Engineering Change Order (ECO)

ECO Number	d2c088d4-b807-49ae-a008-6b7ee9d1e126
Project / Product Name	UNKNOWN
Prepared By	
Date Submitted	2026-05-11T02:39:22+00:00
Revision Number	UNKNOWN
Priority Level	
Departments Affected

title_block [TITLE_BLOCK]

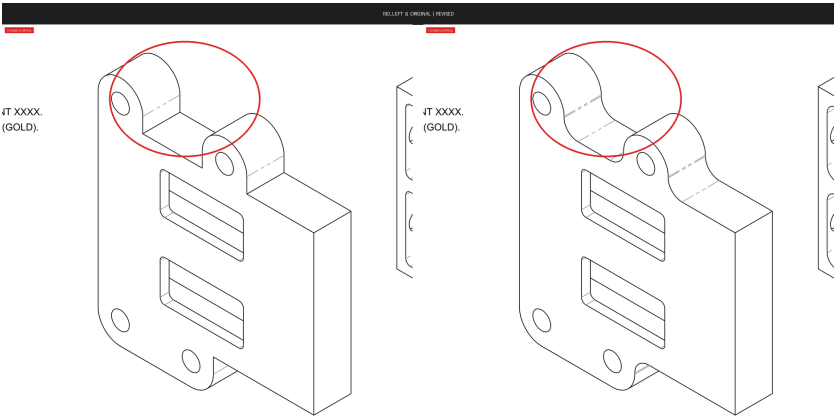
revision [Zone Title Block] title_block.revision changed from 'TS' to None

ISO_LEFT [MATCHED]

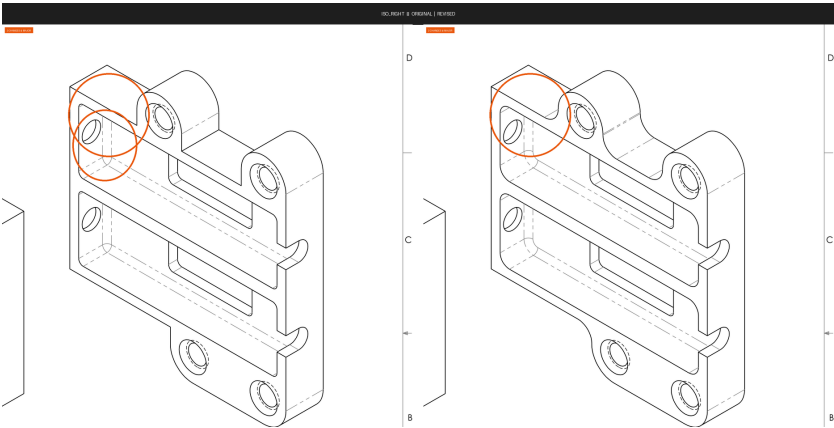
geometry [Zone A4] The raised cylindrical boss on the upper hinge knuckle is removed in the revised drawing.

ISO_RIGHT [MATCHED]

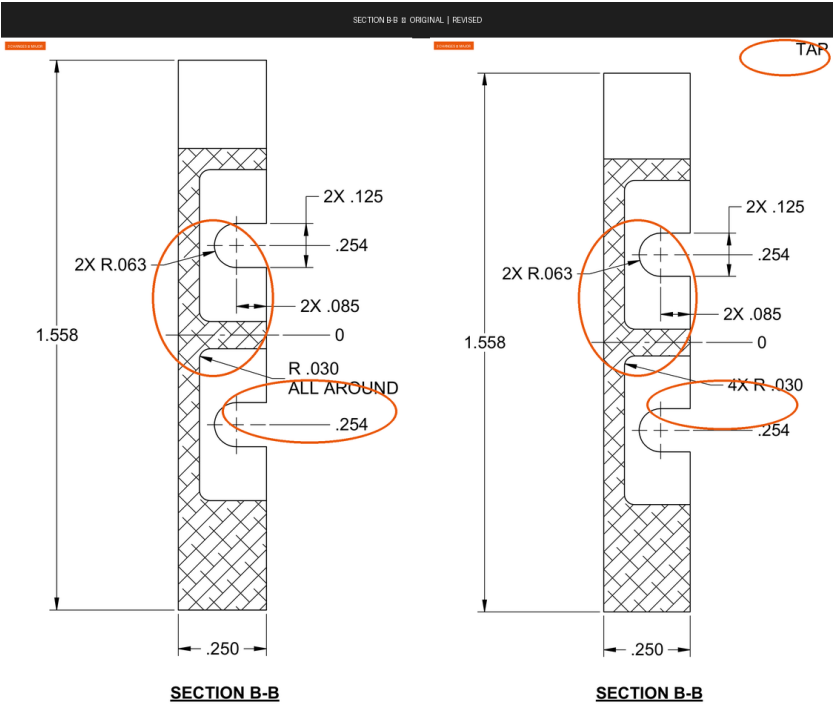
geometry [Zone A3] The upper-left corner of the top body face changed from sharp to filleted in the revised drawing.

feature [Zone B3] A hole feature visible on the top-left face in the original is absent in the revised view.

SECTION B-B [MATCHED]

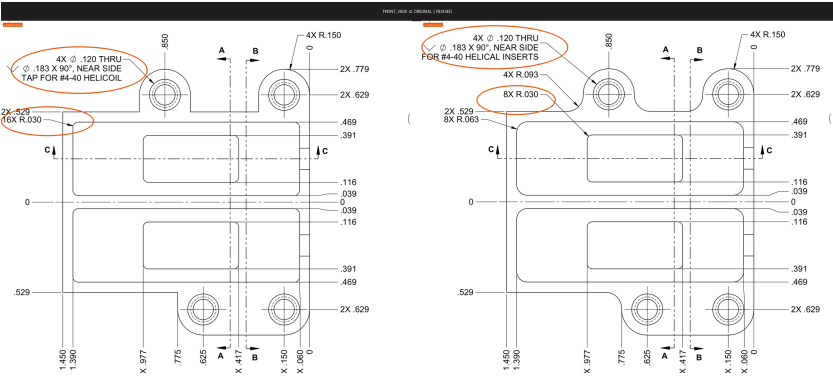
#	Component / Area	Description of Change
	callout	[Zone B7] Radius callout changed from ALL AROUND to 4X discrete count specification.
	annotation	[Zone A7] New TAP annotation added to the upper right of the revised view.
	geometry	[Zone B7] Upper slot pocket bottom corners appear to have added radii in the revised view.

FRONT_VIEW [MATCHED]

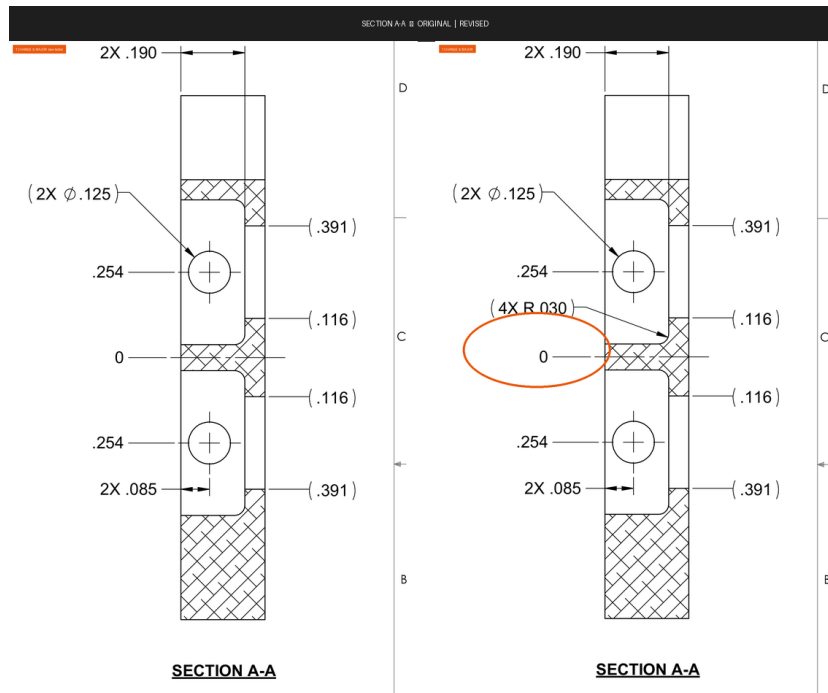
#	Component / Area	Description of Change
	note	[Zone A6] Thread insert callout changed from HELICOIL to HELICAL INSERTS terminology.
	annotation	[Zone A5] Corner radius R.030 quantity reduced from 16X to 8X.

SECTION A-A [MATCHED]

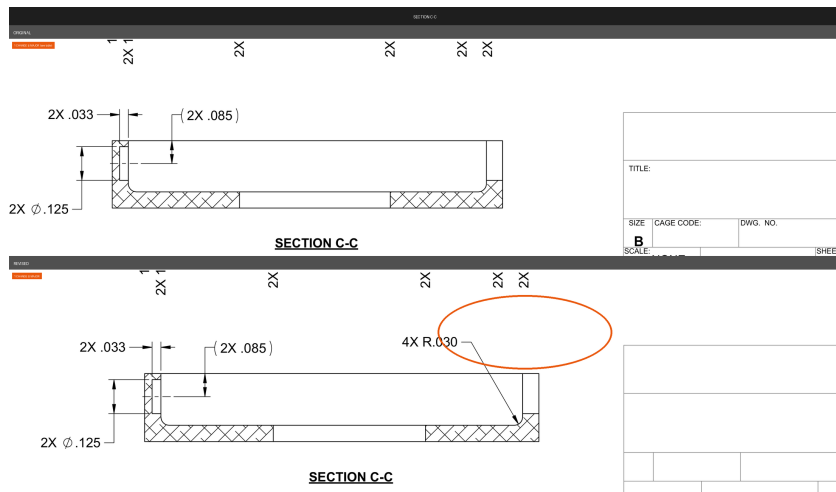
annotation	[Zone B2] New callout (4X R.030) added identifying four corner radii on the slot features.
------------	--
